8XC196KB SPECIFICATION UPDATE

Release Date: December, 1996

Order Number: 272835-002

The 8XC196KB may contain design defects or errors known as errata. Characterized errata that may cause the 8XC196KB's behavior to deviate from published specifications are documented in this specification update.

Figure 1. Quasi-bidirectional Port Circuit

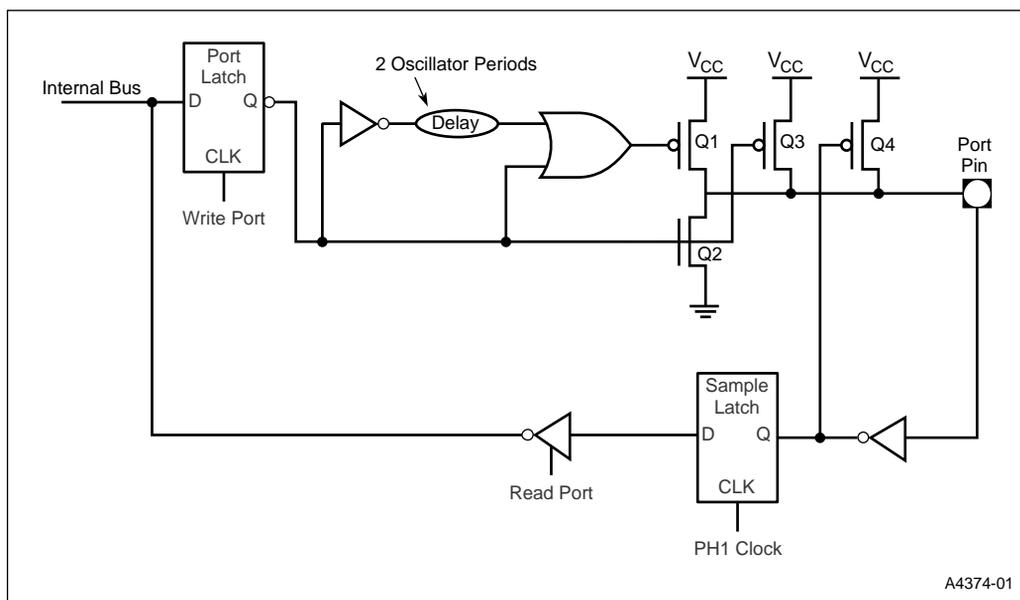
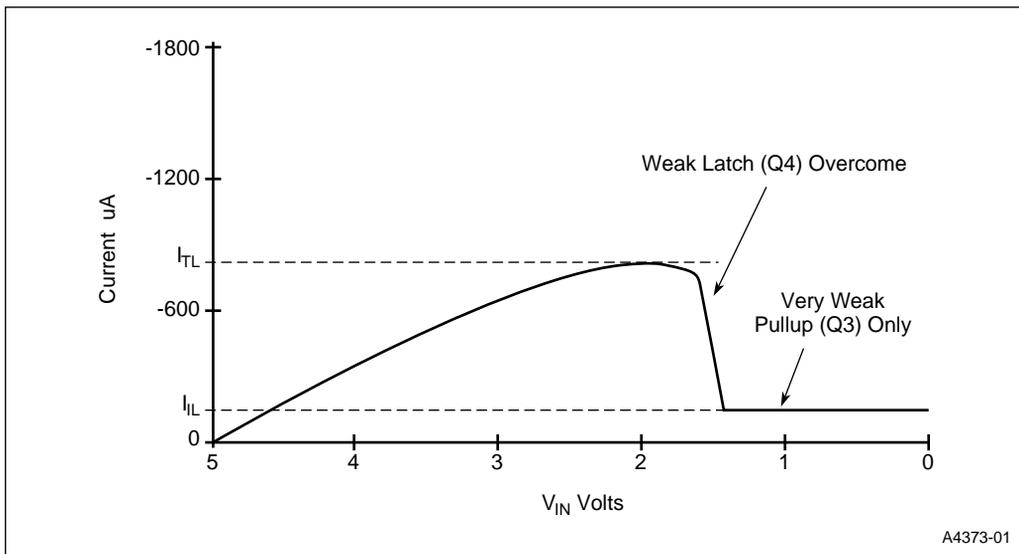
001. I_{TL} Specification Change From -650 μ A to -800 μ A

PROBLEM: To meet the device characteristics at low temperatures, the specification for I_{TL} on the 8XC198 and 8XC196KB/8XC196KB16 (where X = 0, 3, or 7) devices has changed from -650 μ A to -800 μ A.

The I_{TL} specification is the maximum current that the 8XC196KB quasi-bidirectional pins can source during the transition from a logic 1 to a logic 0 input. Figure 1 shows the quasi-bidirectional port circuit. When the port is configured as an input, the output of the port latch is a '0'. Therefore, Q3 is weakly pulling the port pin high. When the external circuitry drives the pin high, Q4 also is turned on and holds the port pin signal high. As the external circuitry decreases the voltage below V_{CC} toward logic 0, Q4 begins to turn off. However, due to transistor characteristics, Q4 will source increasing amounts of current until the threshold voltage of the transistor is reached. Then Q4 will turn off, leaving only Q3 driving the port pin signal high.

Figure 2 shows the transfer characteristic of the port pin during the input's transition from logic 1 to logic 0. The I_{IL} specification shows the amount of current Q3 will source after Q4 turns off. The I_{TL} specification gives the maximum amount of current that Q4 will source during the input's transition from logic 1 to logic 0.

IMPLICATION: Customers using the quasi-bidirectional pins as input should analyze their applications to see if their external circuitry can handle 80 μ A of current from the quasi-bidirectional pins during the transition period explained above.

Figure 3. Improved System Reset Circuit

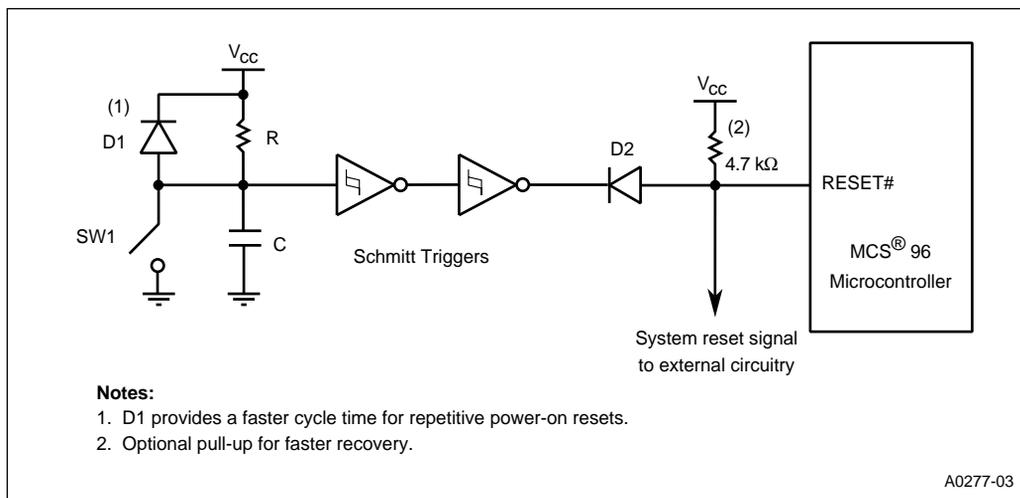
PROBLEM: The following improved system reset circuit shown in Figure 3 may be used in conjunction with the *80C196KB User's Guide (270651-003)*.

The system reset circuit in the *80C196KB User's Guide* has been used successfully by many customers for a long period of time. Both circuits should be evaluated in the user's system.

The main difference between the two circuits is the addition of a 4.7 KΩ pull-up resistor. In some systems, the internal pull-up resistor on the RESET# pin is not sufficient, resulting in a slow rise time. Therefore, the external pull-up resistor was added to allow a more predictable rise time on the RESET# input. The external pull-up resistor is optional, but it may help ensure a clean reset, either for the 8XC196KB or for the external system.

The improved system reset circuit will be included in the next revision of the *80C196KB User's Guide*.
